PLANNING COMMISSION  
STAFF REPORTS AND  
MEMORANDUMS DATED MAY  
20, 2015, JUNE 12, 2015, JUNE  
17, 2015, JULY 1, 2015,  
TOGETHER WITH  
POWERPOINT PRESENTATIONS  
FROM STAFF AND APPLICANT  
FOR MAY 27 AND JUNE 24  
HEARING DATES

## Staff Report

APPLICATIONS: **South Cooper Mountain High School - land use case files CU2015-0003, DR2015-0029, LD2015-0004 and ADJ2015-0004**

**TOPIC: Site Fencing**

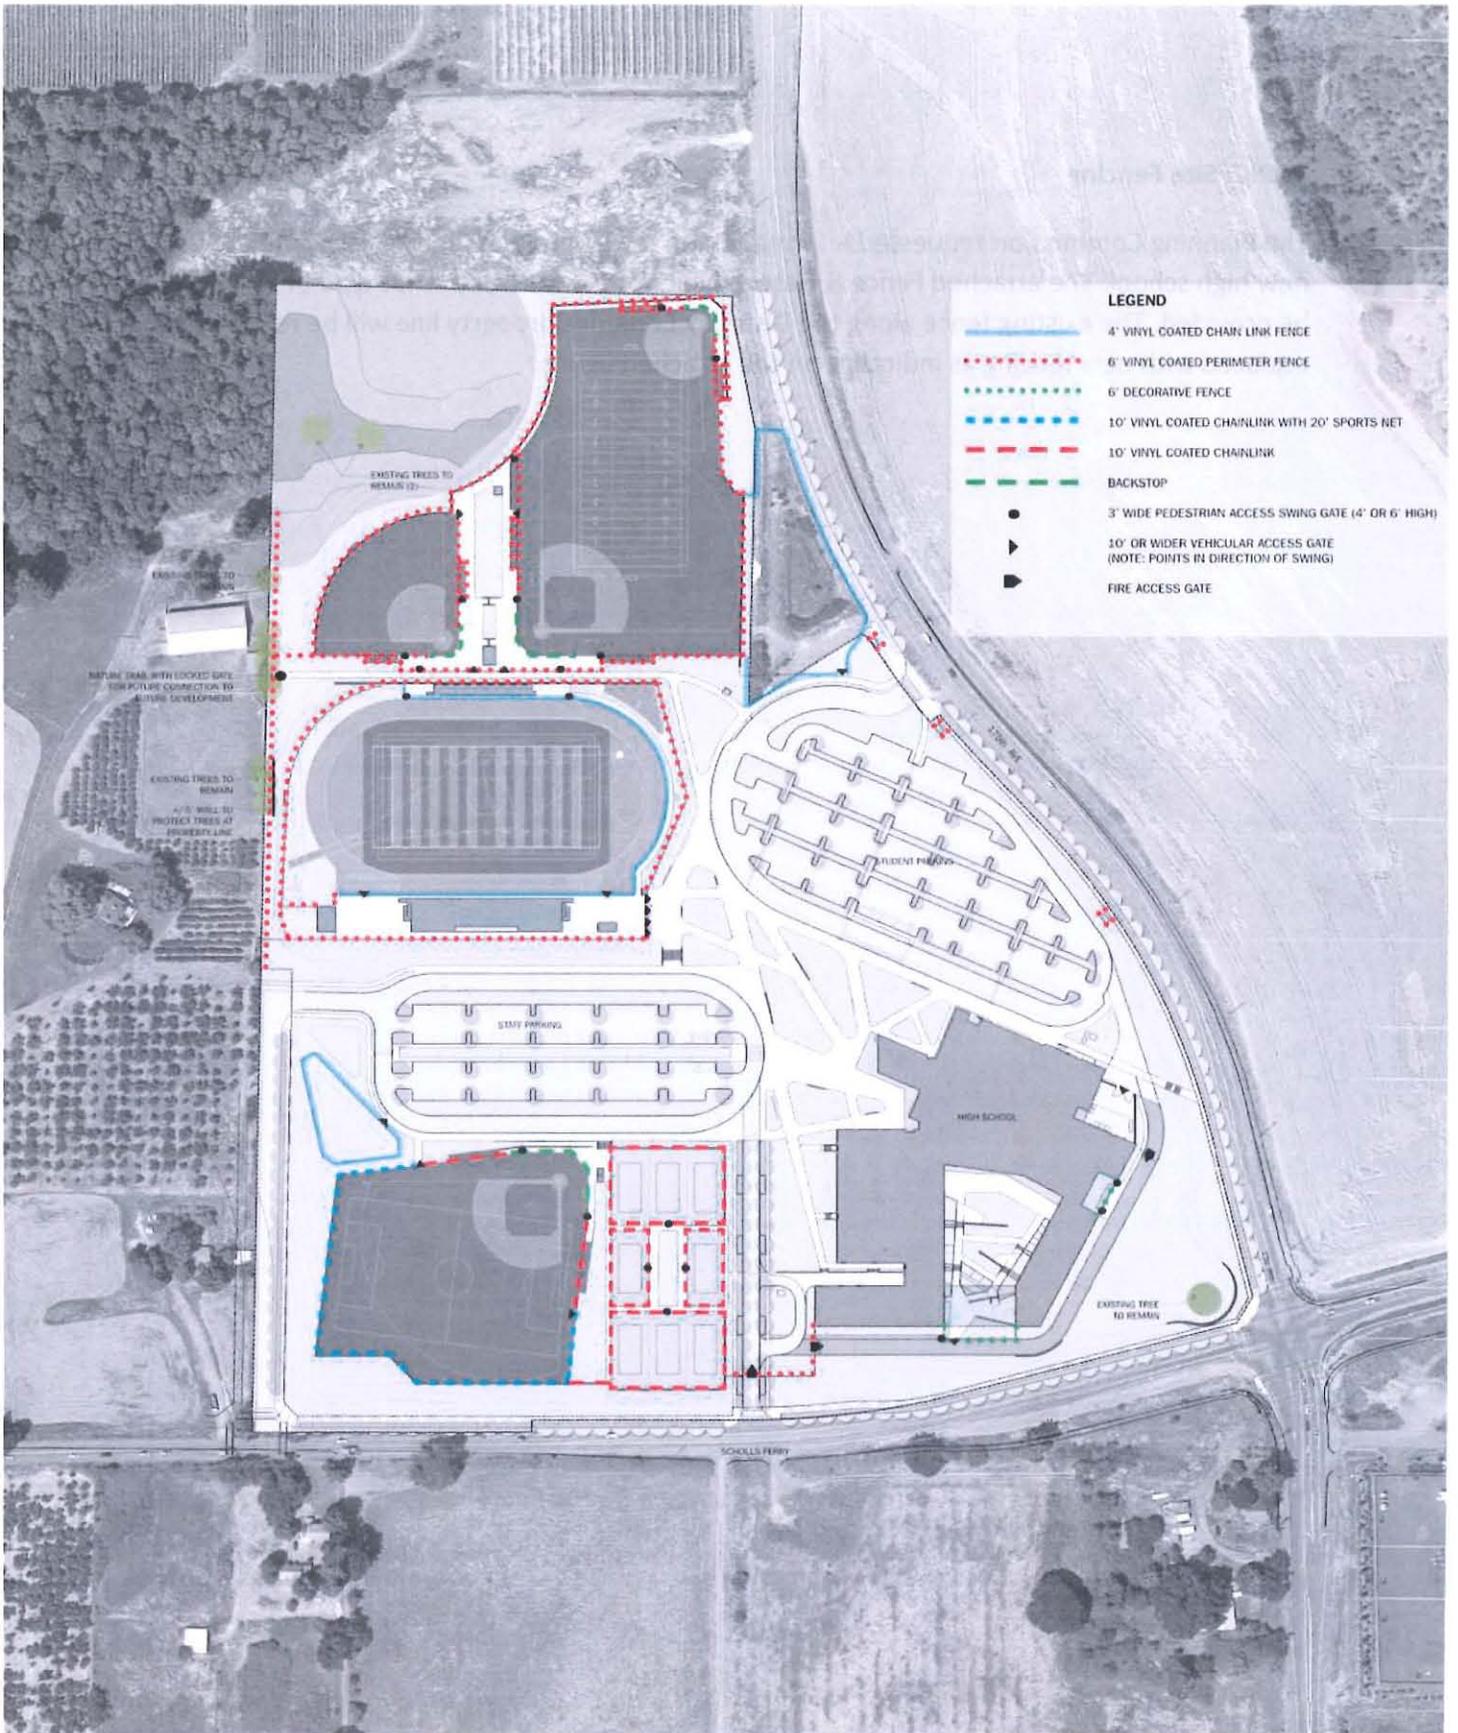
The Planning Commission requested information on the location of fencing associated with the new high school. The attached Fence & Gate exhibit notes where and what type of fencing will be provided. The existing fence along the District / Edmonds property line will be removed and replaced with new fencing as indicated on the attached figure.

Figure 1: Community Plan Bicycle & Pedestrian Framework

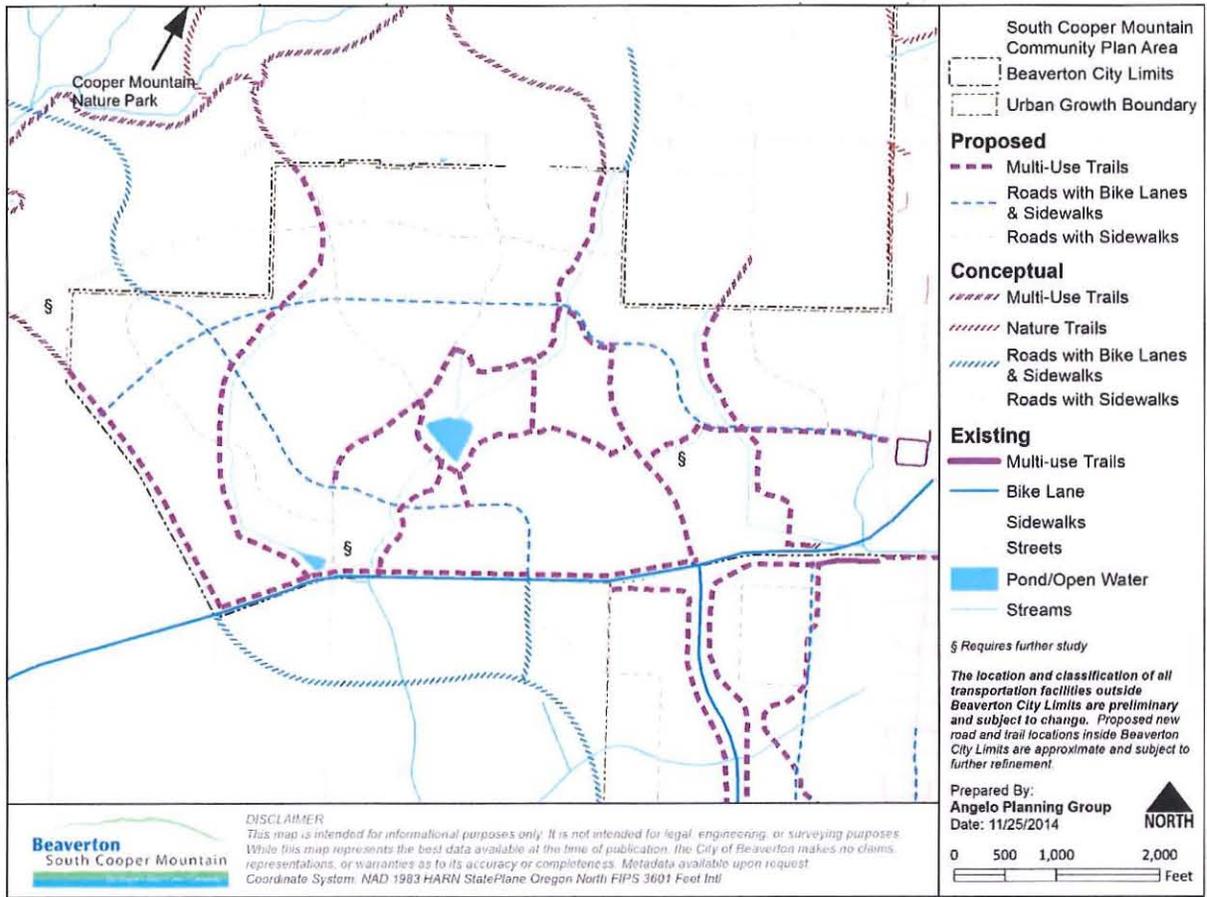
*c. School to School Trail: A multi-use path shall link from SW Loon Drive at Scholls Heights Elementary school to SW 175th Avenue at the planned high school site as shown in Figure 11 in order to provide safe routes to both schools and to connect neighborhoods to the east to the planned high school.*

Figure 11 from the Community Plan depicts the pedestrian and bicycle framework for the area and shows the multi-use trail location. See next page for Figure 11.

Based on this information, the 10-foot wide trail facility that the District is proposing to construct along the site's frontage with SW 175<sup>th</sup> and SW Scholls Ferry Rd. is consistent with the Community Plan and THPRD's Trails Plan. However, THPRD submitted a letter (dated May 27) asking that the District consider a 12-foot width for the trail. The District is willing to consider this request and will continue to work with THPRD to further develop the trail concept and reach a satisfactory design that will facilitate bicycle and pedestrian connections in this area.

**TOPIC: Circulation in the student drop-off / pick-up area & parking numbers with fire lane**

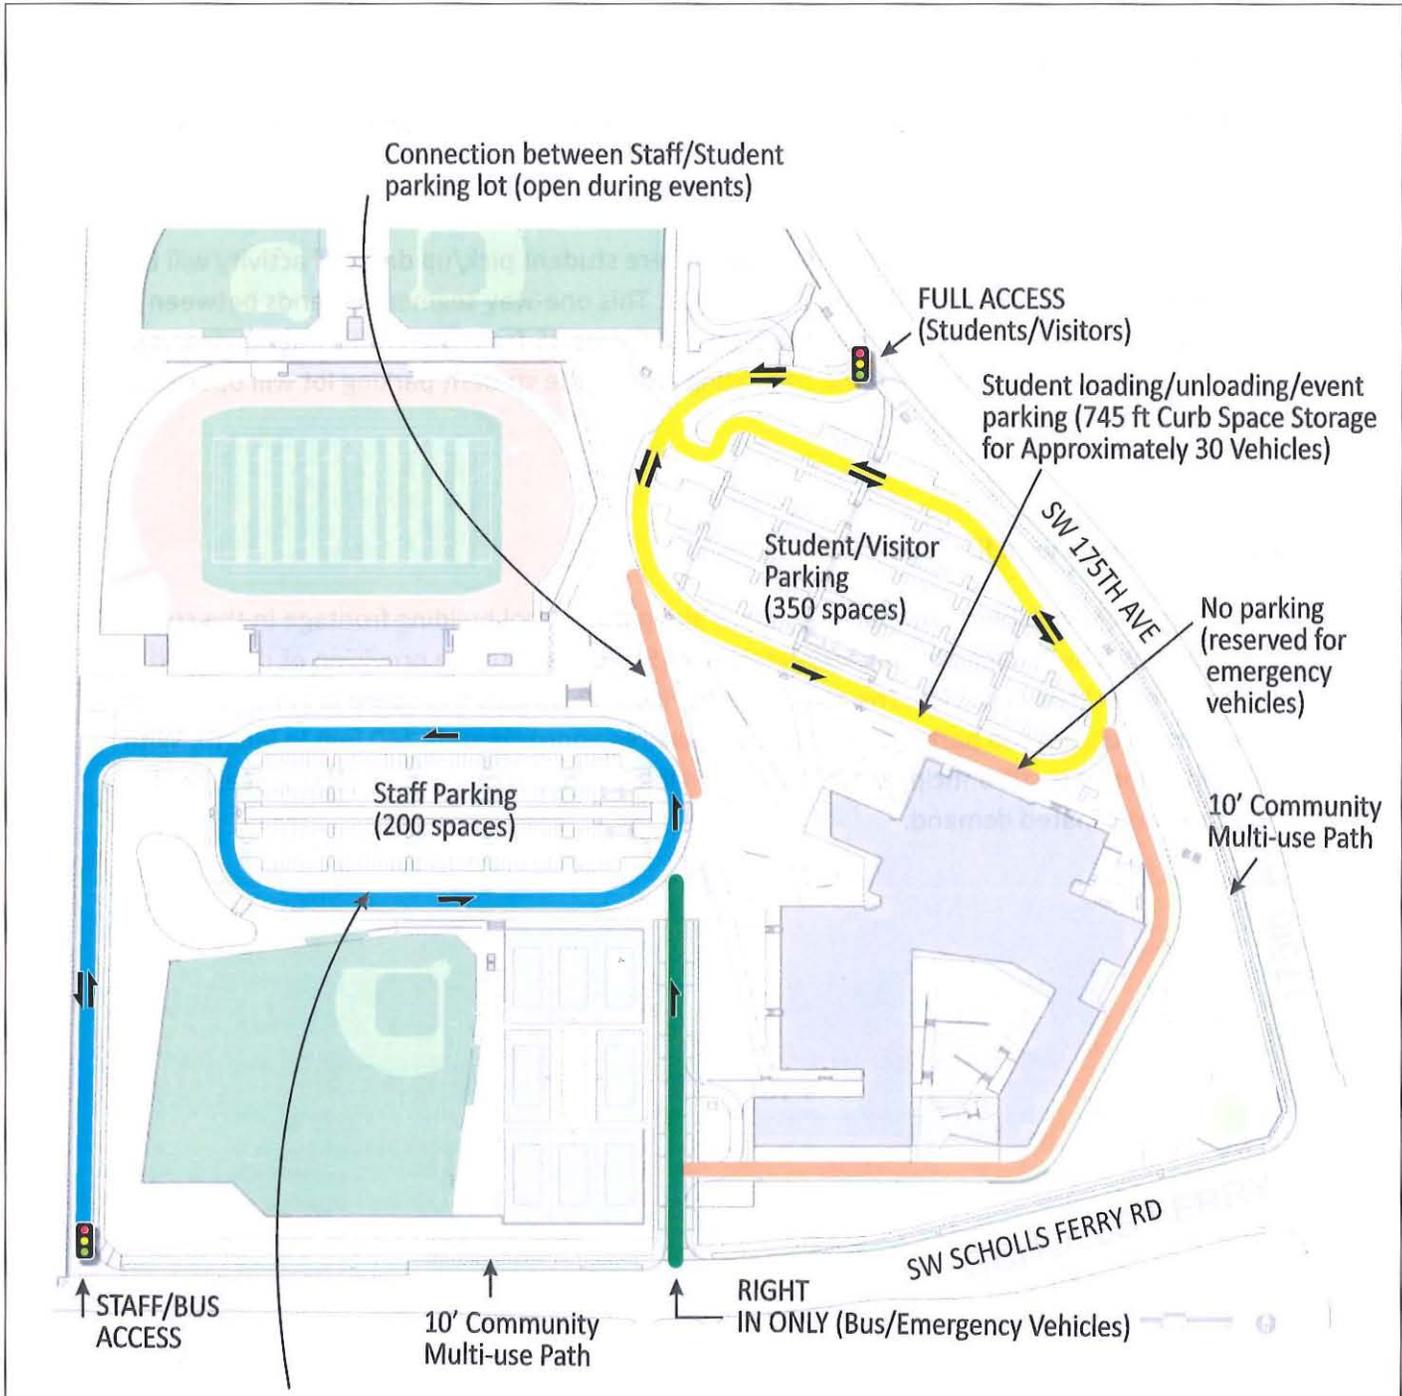
The circulation aisle along the school frontage where student pick/up drop off activity will take place will operate as one-way (counter clockwise). This one-way segment extends between the southernmost drive aisle as shown in the attached Figure 15 from the Traffic Impact Analysis (TIA). The remaining segments of the circulating aisle in the student parking lot will operate as two-way.

Staff Response and Finding: Staff refer to Figure 15 of the District Response – June 10. Figure 15 illustrates the flow pattern of vehicles and the queue length provided (745 feet or 30 vehicles) for student loading and unloading. According to the District, the school frontage where student pick/up drop off activity will take place will operate as one-way (counterclockwise). The District also explains how the remaining segments of the circulating aisle in the student parking lot will operate as two-way. Transportation staff has reviewed the plan and recommend a condition of approval that would require the outer ring in the student parking lot be signed for one-way (counterclockwise) direction (see proposed Condition No. 25 – revised). For football games and other large events, staff acknowledges that this circulation pattern could change if and when the vehicle connection between staff / student parking lots is opened. In that case, staff anticipates temporary signs and event staff to be available to direct vehicles and pedestrians accordingly.

<p><b>LEGEND</b></p> <p>○ - Study Intersection</p> <p>↕ - Student Trip Distribution Percentage</p> <p>↔ - Staff Trip Distribution Percentage</p>		<p><b>DKS</b></p> <p>No Scale</p>	<p><b>Figure 10</b></p> <p><b>PROJECT TRIP DISTRIBUTION</b></p>

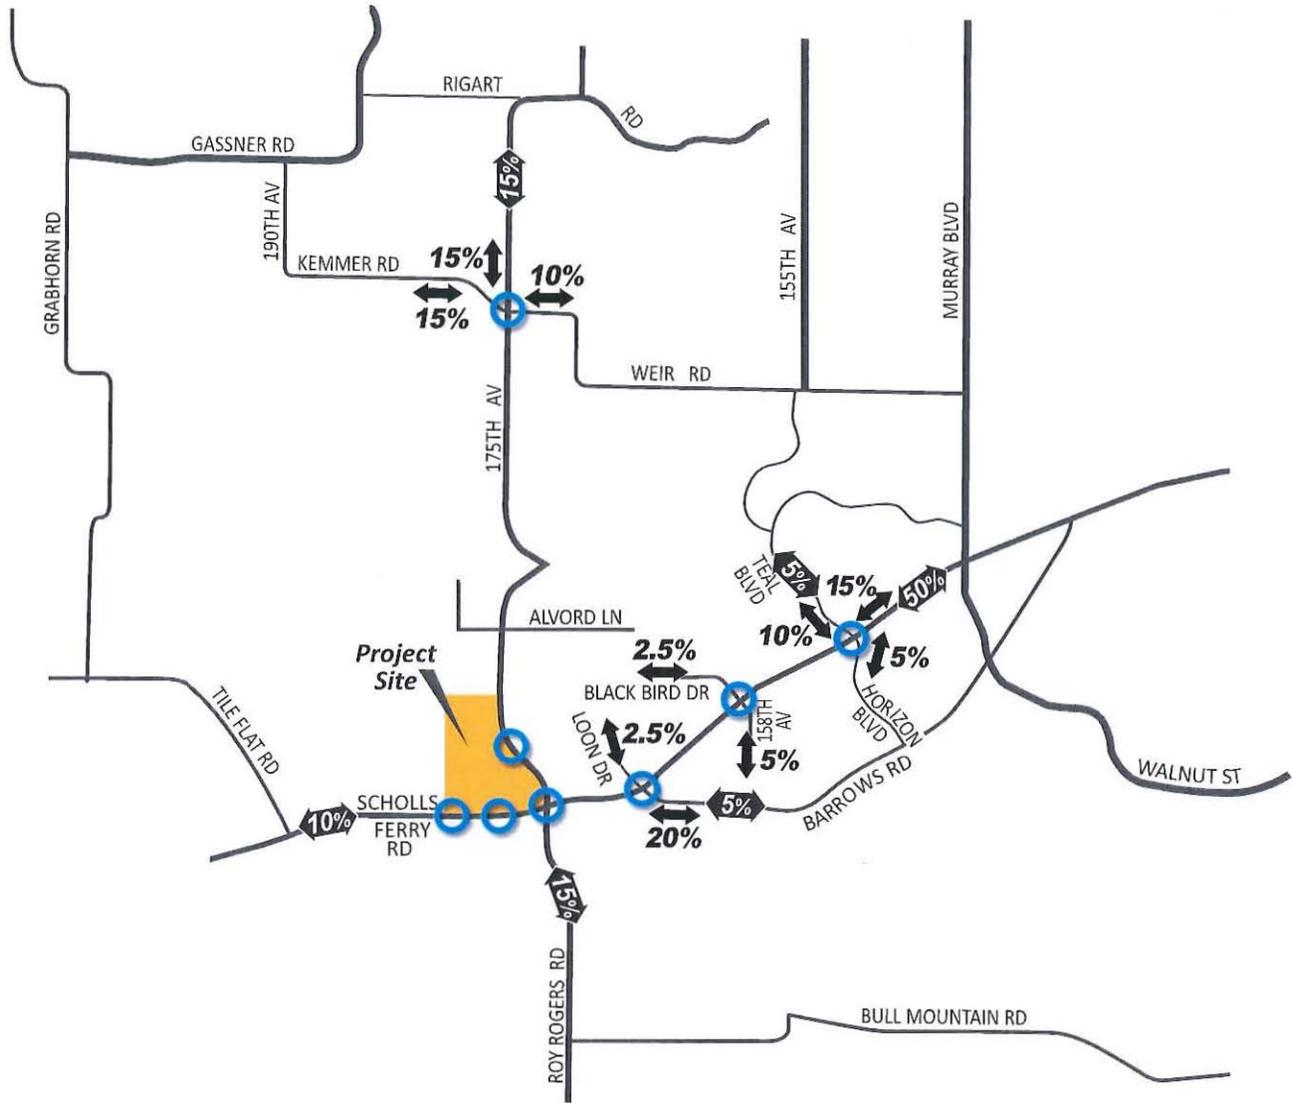
In response to testimony and concerns about the anticipated directional flow of students arriving to school off-site, the District refers to another exhibit (Figure 10) that shows projected student trip distribution from all streets in the immediate vicinity of the school site.

The anticipated distribution of student and school staff traffic is shown in Figure 10 of the TIA and is attached. The distribution was coordinated with School District staff as the school attendance boundary has not been determined.

**TOPIC: New Collector Extension**

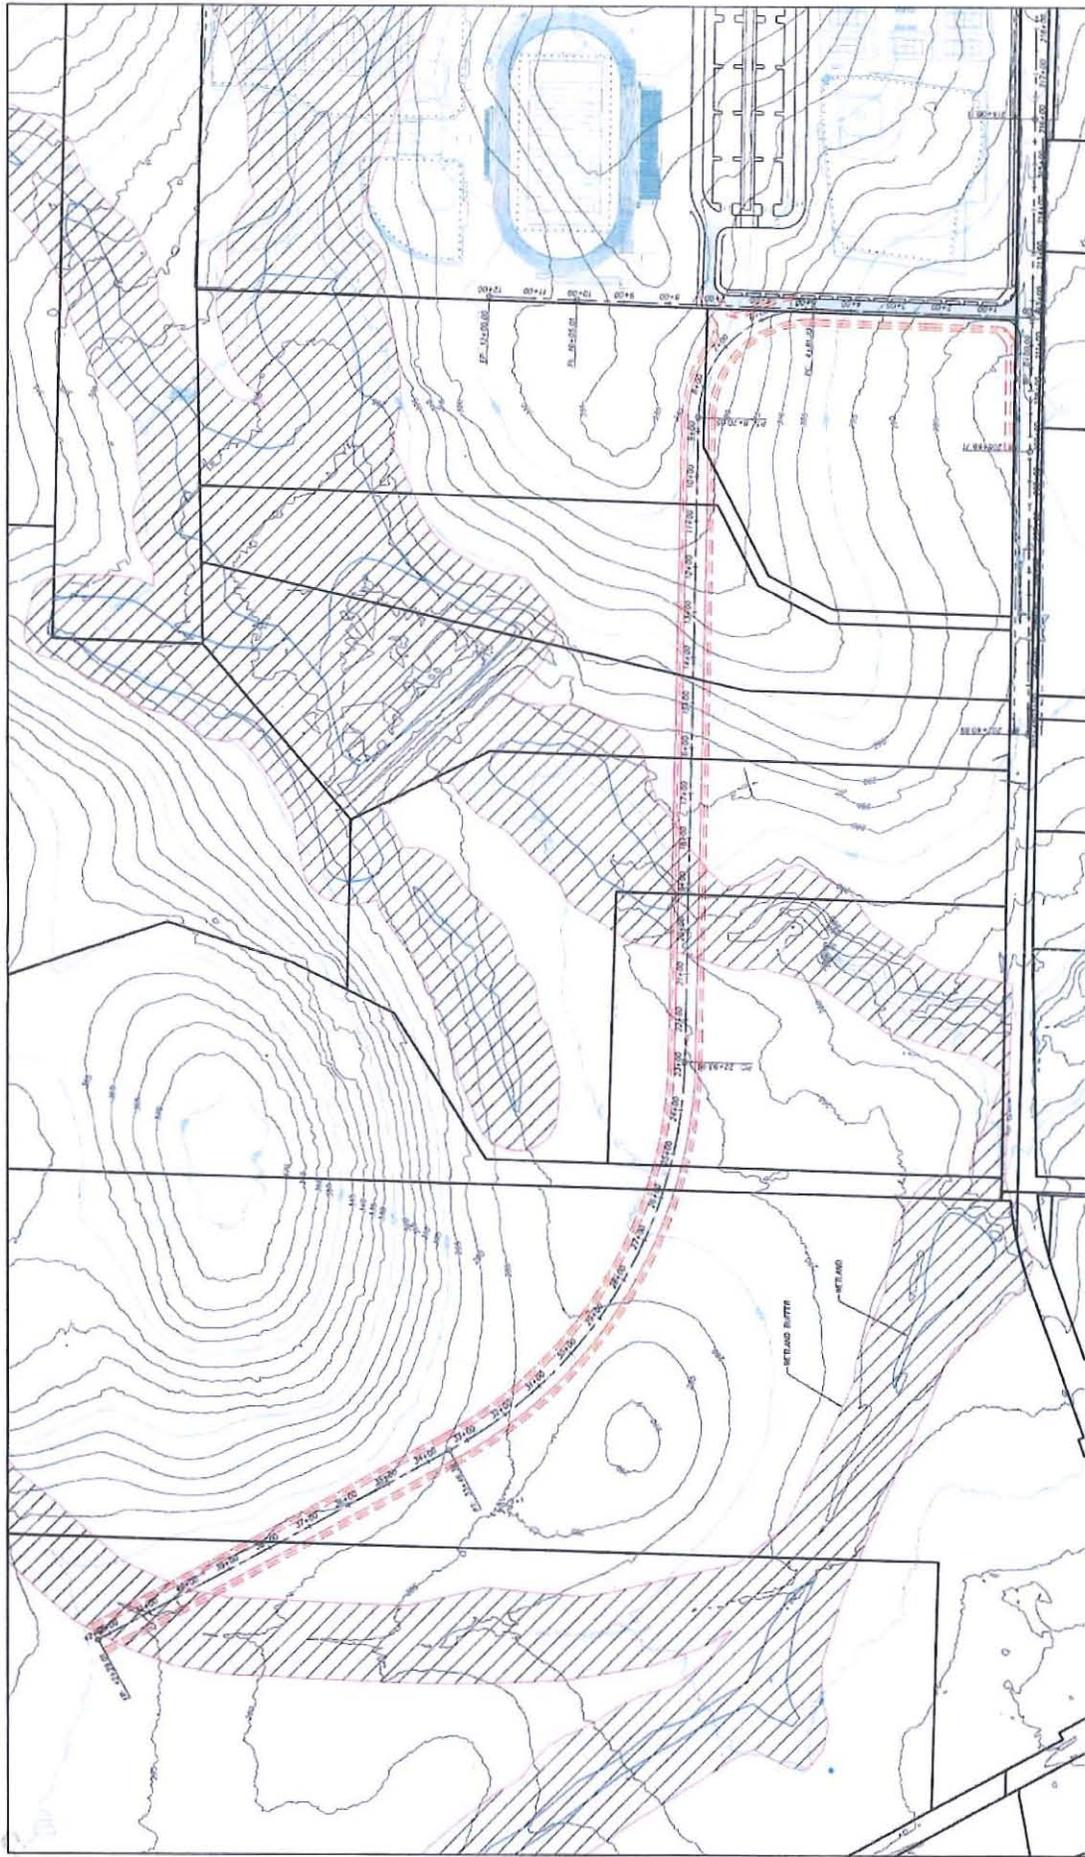
The attached exhibit shows how the New Collector Road could be extended to the west to serve other properties as they develop. The City requested that the BSD provide a concept of how the New Collector could be extended by others as properties develop. This concept for the extension of the New Collector to the west follows the conceptual alignment shown in the South Cooper Mountain Plan.
